TRACT Y, VILLA DEL NORTE

MARK GOODWIN & ASSOCIATES, P.A. CONSULTING ENGINEERS P.O. BOX 80606 ALBUQUERQUE, NEW MEXICO 87199 (505) 828-2200, FAX (505) 797-9539		CITY OF ALBUQUERQUE PUBLIC WORKS DEPARTMENT	
TITLE: GRADING PLAN BERNARDO TRAILS CITY PARK AT VISTA DEL NORTE			
DESIGN REVIEW COMMITTEE	CITY ENGINEER APPROVAL	LAST DESIGN UPDATE	MO./DAY/YR.
CITY PROJECT NO.	ZONE MAP NO.	SHEET	OF
	E-16	1	2
DESIGNED BY: DMG DRAWN BY: SV CHECKED BY: DMG		DATE: 8/03 DATE: 8/03 DATE: 8/03	
F:\A05JOBS\A5042 Vista del Norte Park\GRADING\5042GD3A.dwg\02-27-07 SV CAR RDQ DLH			
MAR 12 2007 HYDROLOGY SECTION

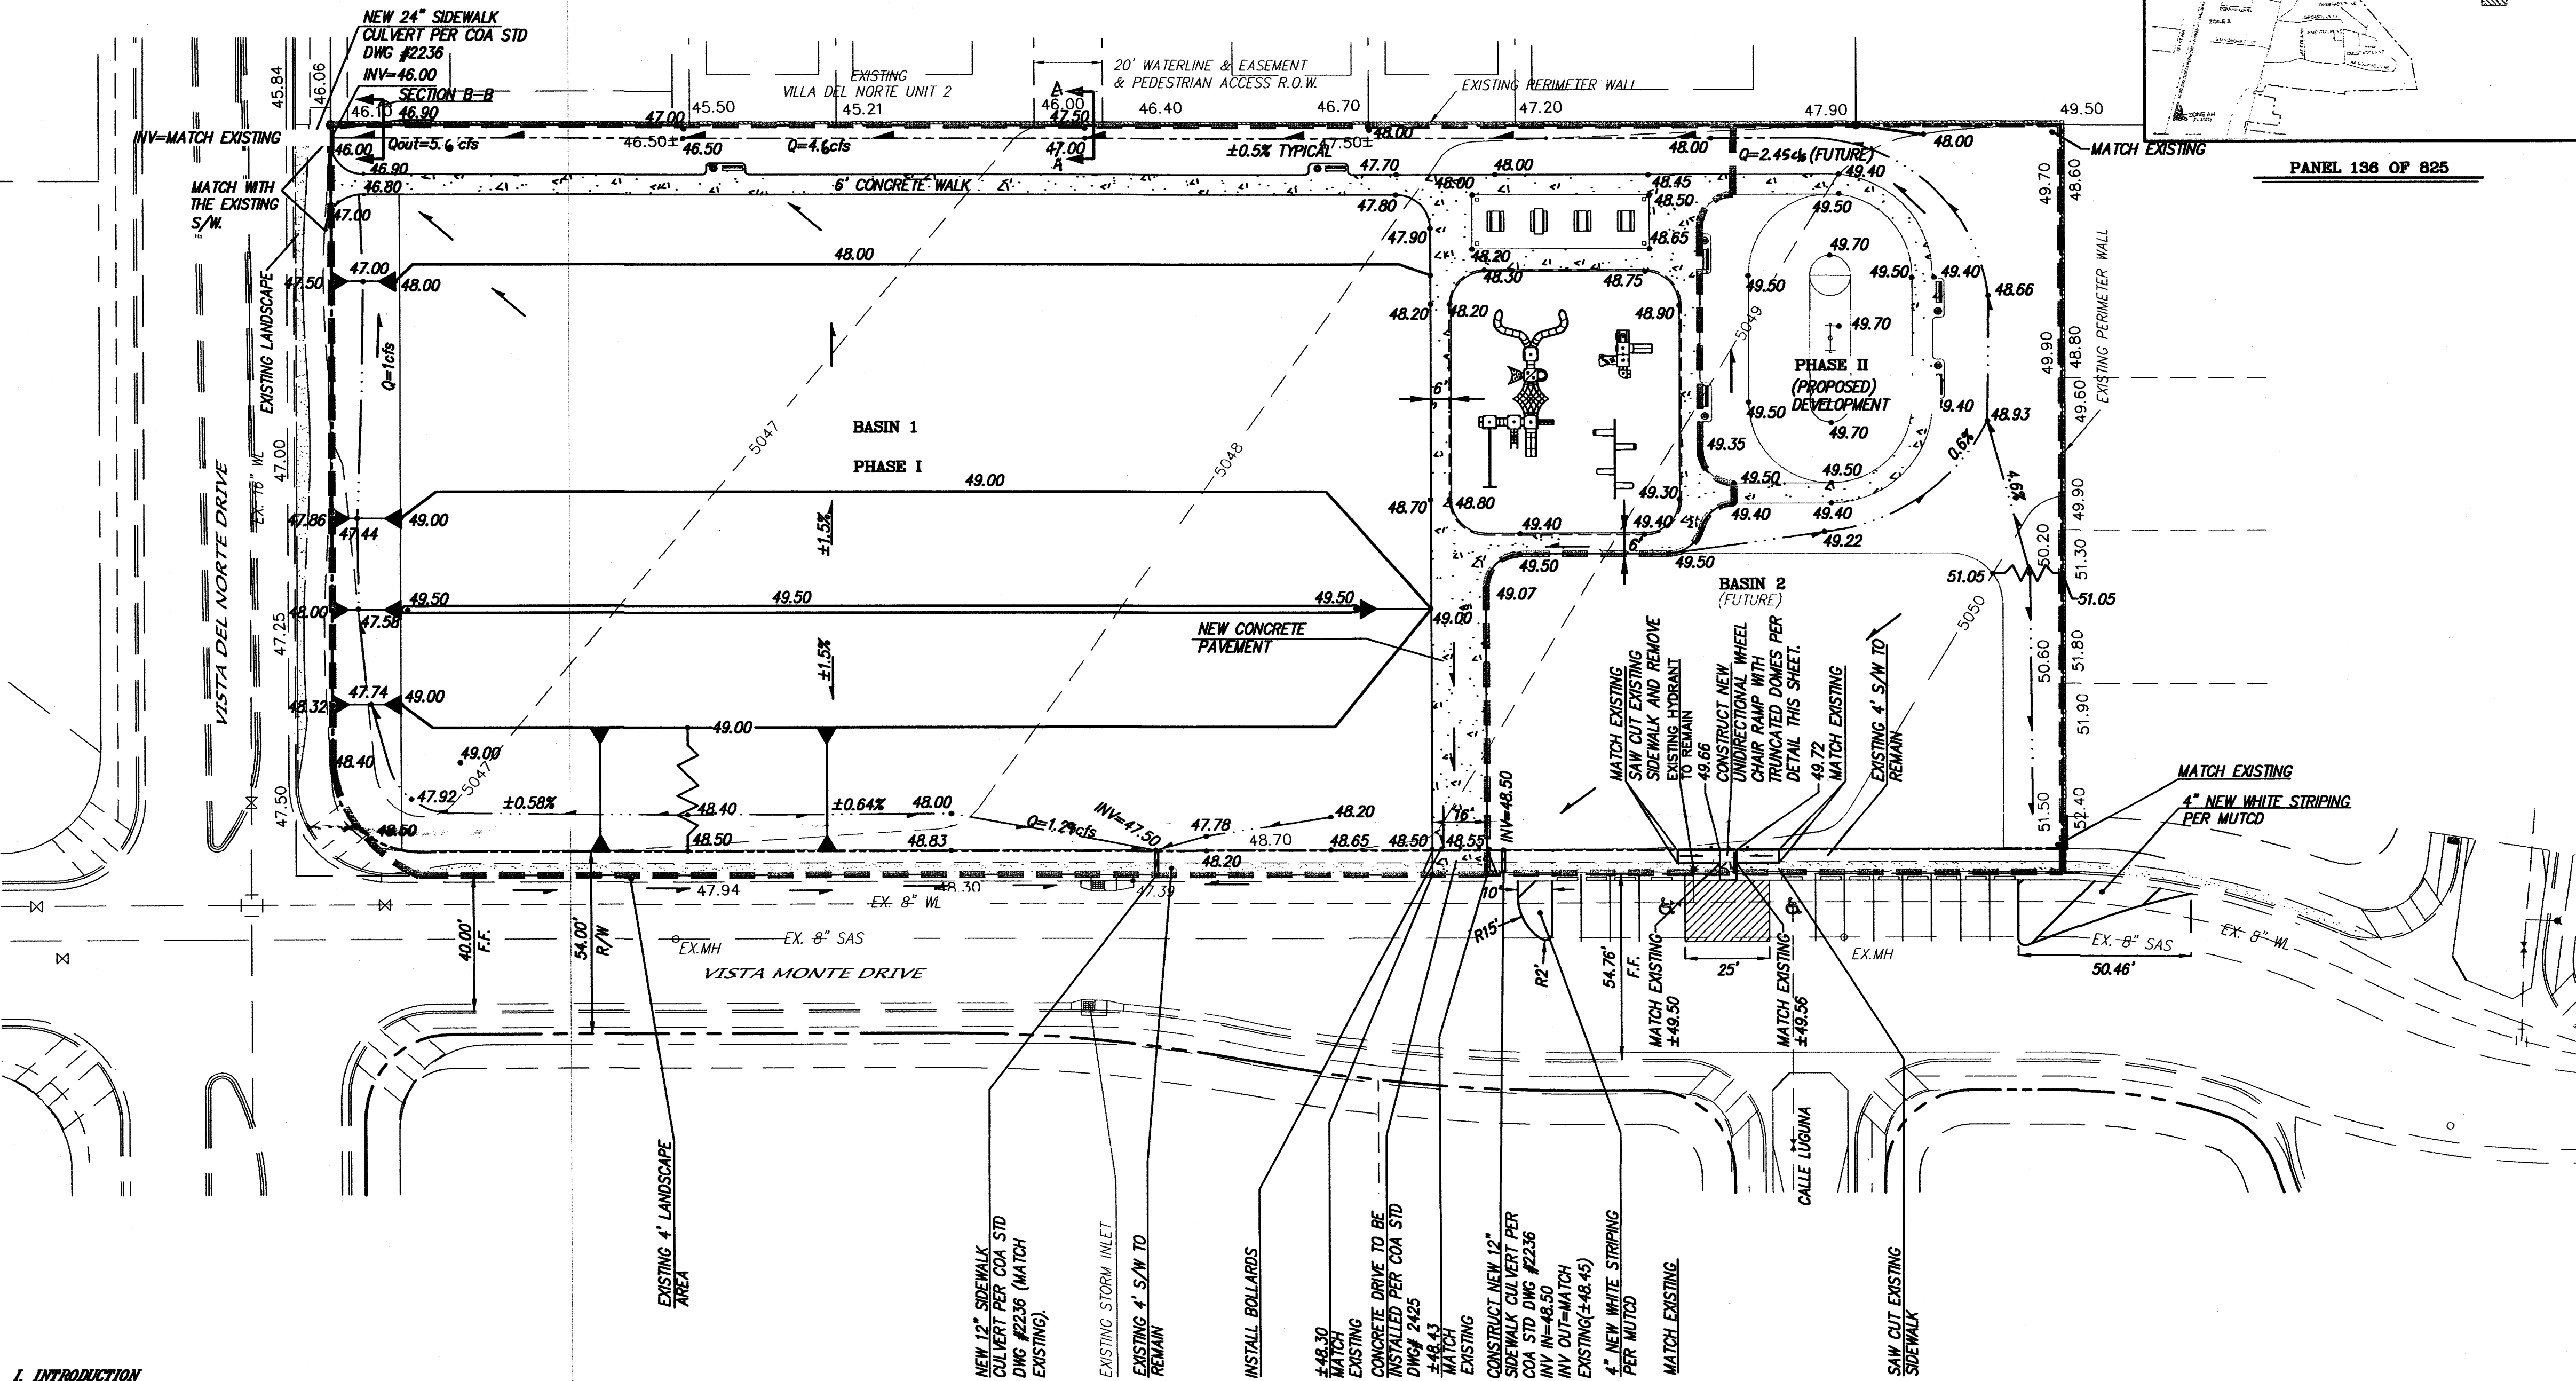
SEE CALC FOR CORRECT VALUES
